# SERVICE BULLETIN

## ENGINE - HP TURBINE ROTOR AND STATOR ASSEMBLY - TO PROVIDE A NEW STAGE 1 HPT AIR SEAL - CATEGORY CODE 8 - MOD.ENG-72-0131

# V2500-ENG-72-0131

Location of Stage 1 HPT Air Seal  
Fig.1

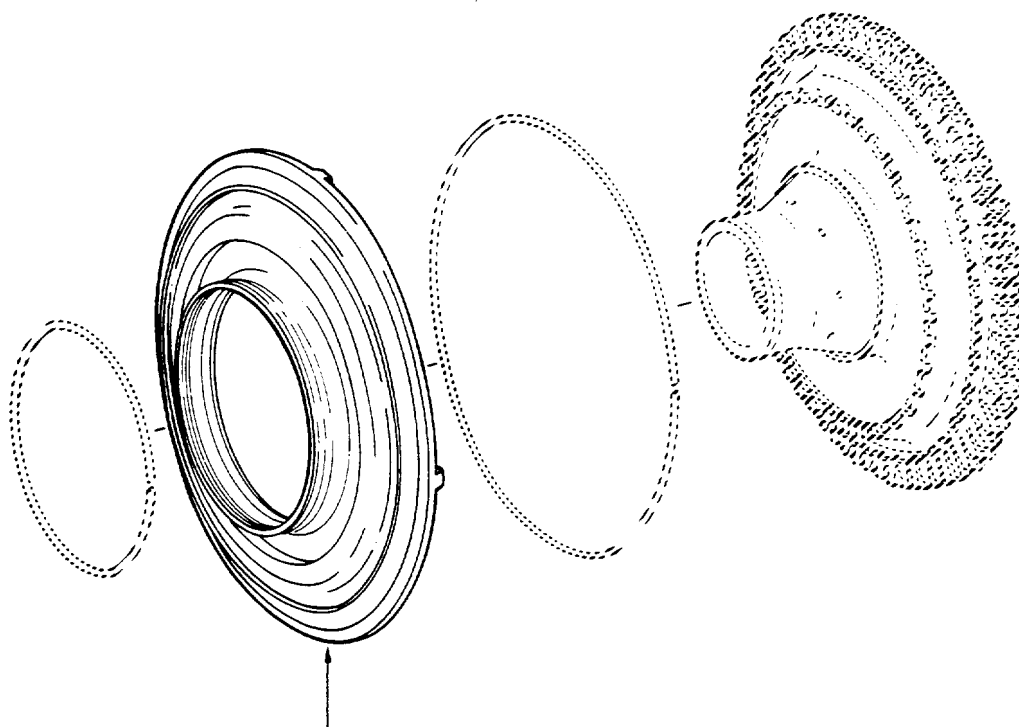
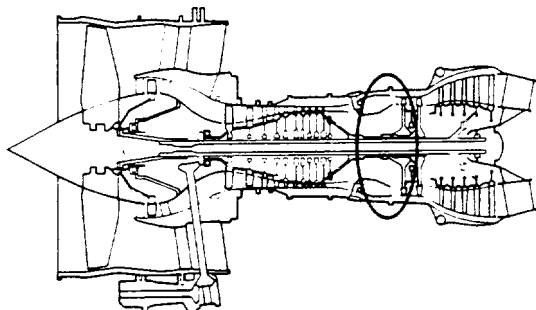
REPLACE THE 2A0488 STAGE 1 HPT  
AIR SEAL (1 off), OR 2A1105 STAGE 1  
HPT AIR SEAL (1off) OR THE 2A1271  
STAGE 1 HPT AIR SEAL (1 off) WITH THE  
2A1350 STAGE 1 HPT AIR SEAL (1 off)

- (1) Assemble the HP Turbine Rotor and Stator Assembly by the approved procedures given Reference (2), Chapter/Section 72-45-00, Assembly, Config-1 and Config-2.
- (2) Use the 2A1350 Stage 1 HPT Air Seal.

Family tree - Stage 1 HPT Air Seal  
Fig.2

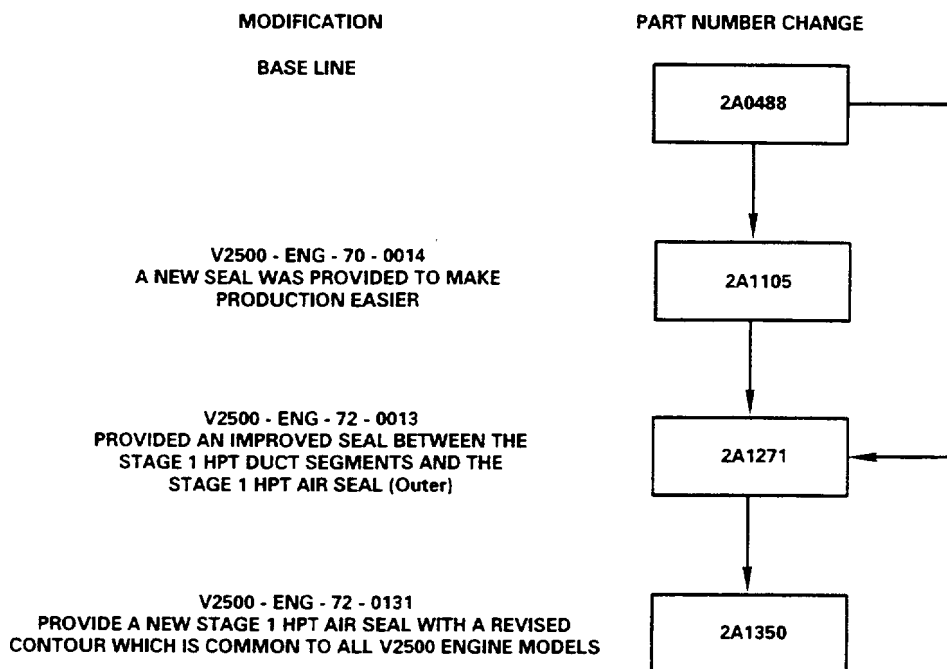
New Part No. (ATA No.)	Qty.	Est'd Unit Price (\$)	Keyword	Old Part No. (IPC No.)	Instructions Disposition
2A1350 (72-45-12)	1		Seal, Air, Stage 1, HPT	2A0488 (01-040) or 2A1105 (01-040) or 2A1271 (01-040)	(A) (B)  (C)  (B)
